Further Information to Application for Project Change
Northern Link Road Tunnel Project
November 2010

This report has been prepared in response to a request from the Coordinator-General for further information on the project changes, after consideration by the Coordinator-General of the submissions received from the community. Responses to agency submissions will be addressed in a separate report. This report is not a stand alone report and should be read in conjunction with the Application for Project Change October 2010 report.

■ Figure 6-1 Eastern Connection Noise Barriers Concept Design 1

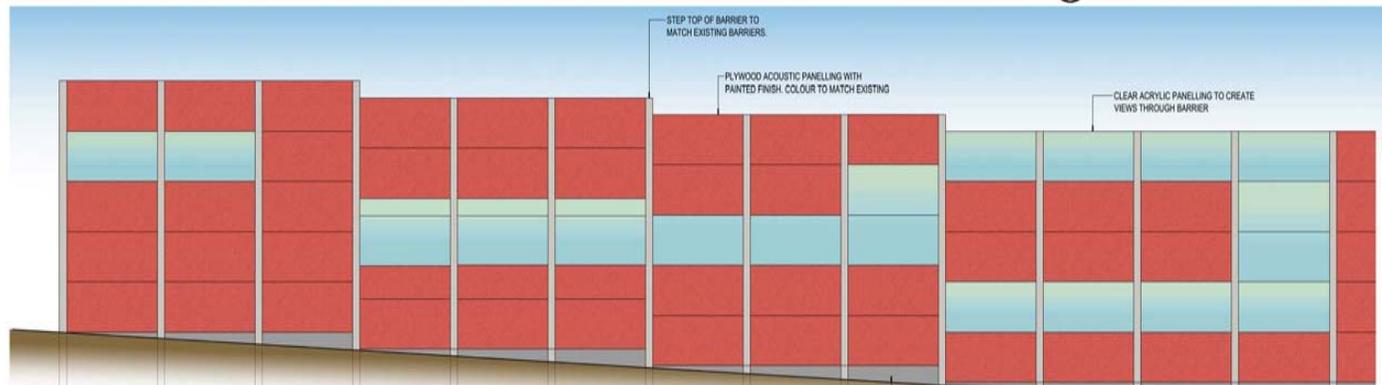
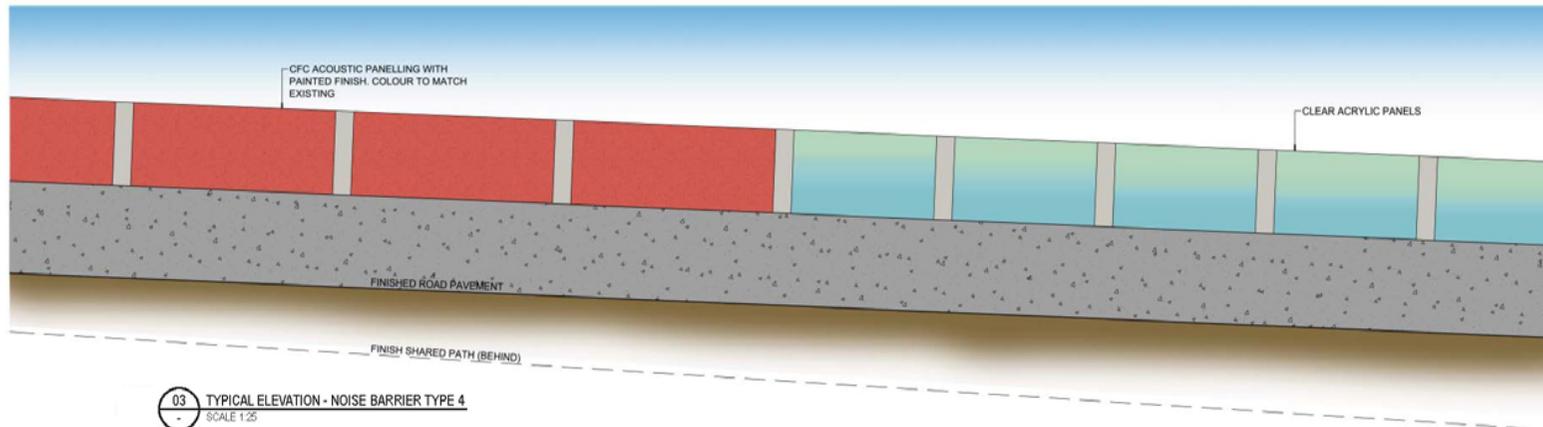
Detailed 3D noise modelling of the new portal/transition areas will form part of the detailed design phase of the project. Noise mitigation would be designed and implemented to ensure compliance with the Coordinator-General's Conditions. Preliminary modelling of the new portal/transition areas has been undertaken which recommend a number of mitigation measures to ensure compliance with the Coordinator-General's Conditions. These mitigations measures were reported in the Application for Project Change as follows:

The concept design for the proposed noise barriers for the eastern connection are shown in **Figure 6-1** and **Figure 6-2**. These concepts are subject to detailed design, which would be informed by the detailed 3D noise modelling.
